INSTRUCTION TO SERVICE

ITS: 6369

SECTION:	260 Battery Compartment
WRITTEN BY:	Talha Wasif
SUBJECT:	Rewire voltage regulator power

Figure 1: Fuse box with door open

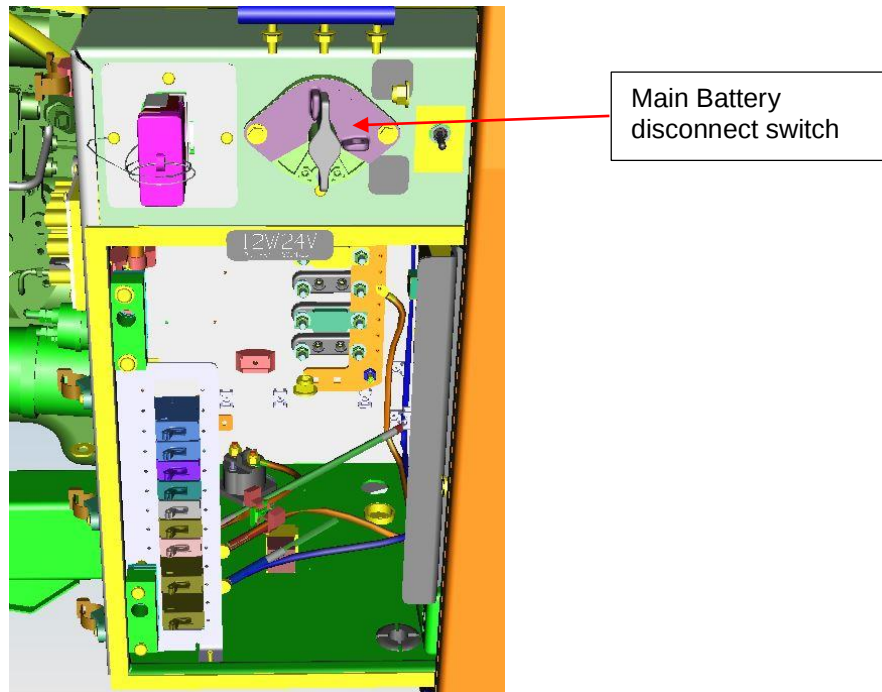
1. Turn the main battery disconnect switch to the “OFF” position by accessing it through the fuse box panel on the rear right hand side of the bus.

Figure 4: Electrical schematic for reference

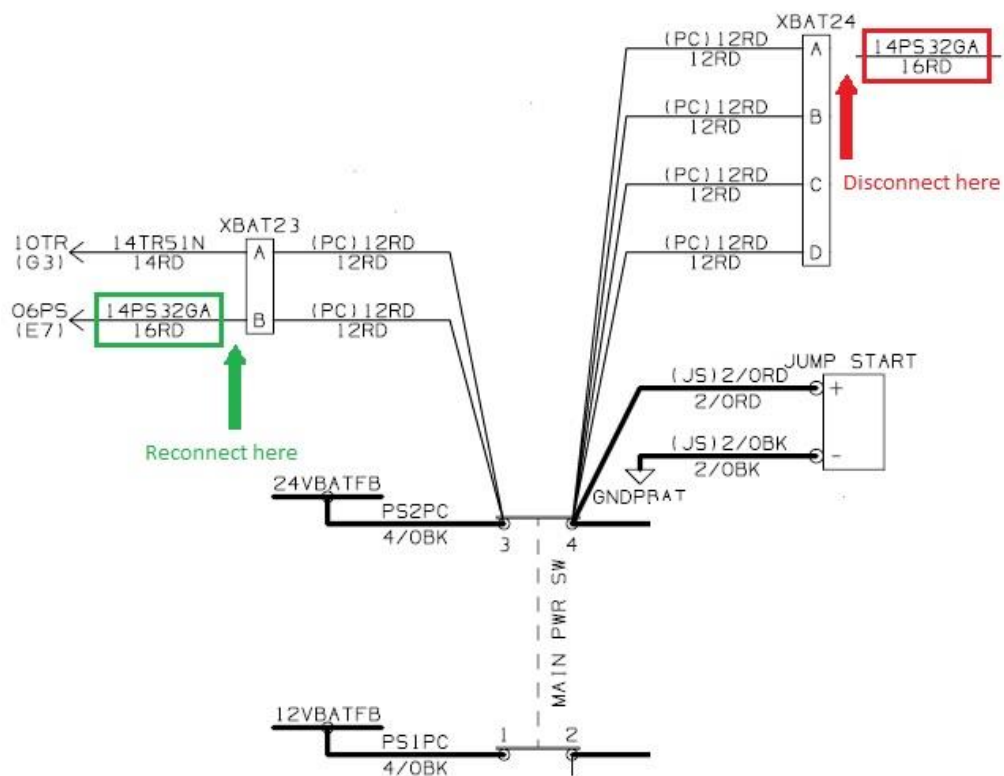
2. Locate the connector XBAT24 located inside the fuse box.
3. Disconnect the wire labelled “14PS32GA” from cavity A of the XBAT24 shear, as shown in Fig 2.

4. Cut off the existing terminal.
5. Terminate the wire with a socket (PN: 102879).
6. Locate the connector XBAT23.
7. Insert the newly terminated wire into cavity B of the XBAT23 tower as shown in Fig 3.

XBAT23
 ○ A: TR51N
 ○ B: PS32GA
